## Wetland Consulting Services

August 16, 2022

RE: Monitoring Report 53A South Hunt Road Amesbury

Photo D. Coir logs still in place, but stakes in the logs were not been installed as previously recommended.

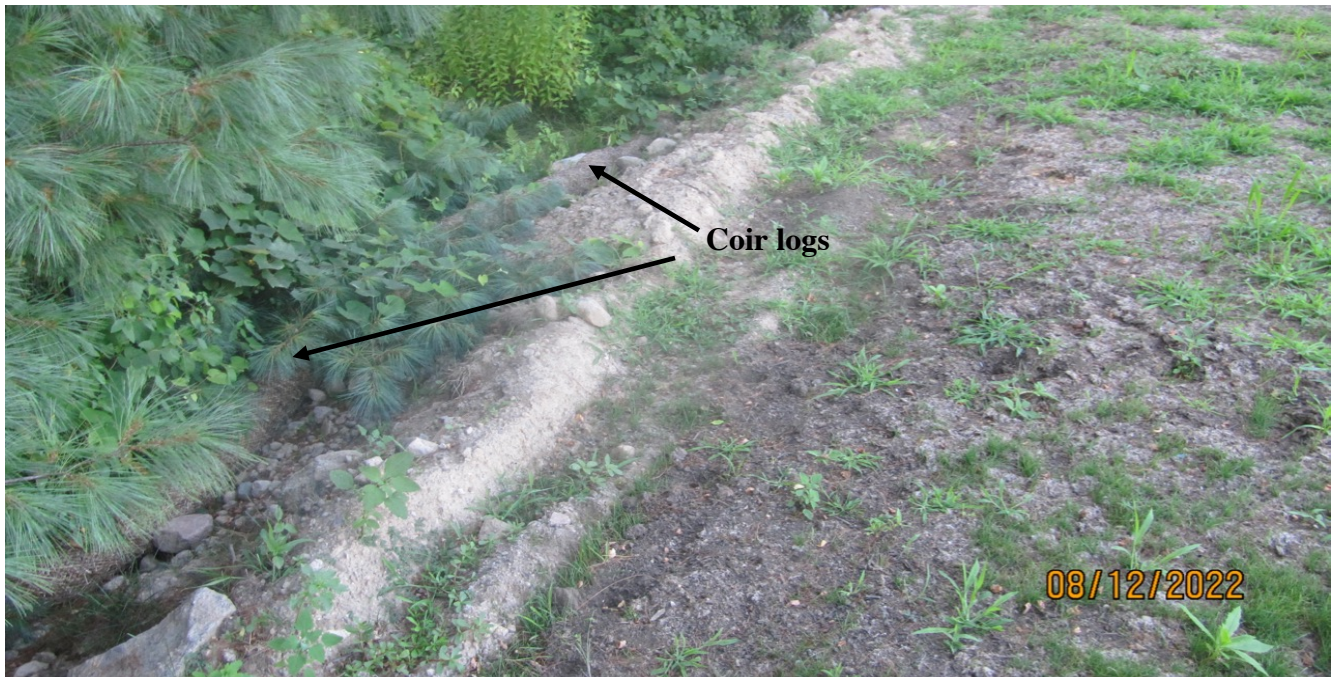
Erosion control (coir logs) have been installed around most of the perimeter (see Photos D and E), but the logs have not been staked as was recommended in my June report.
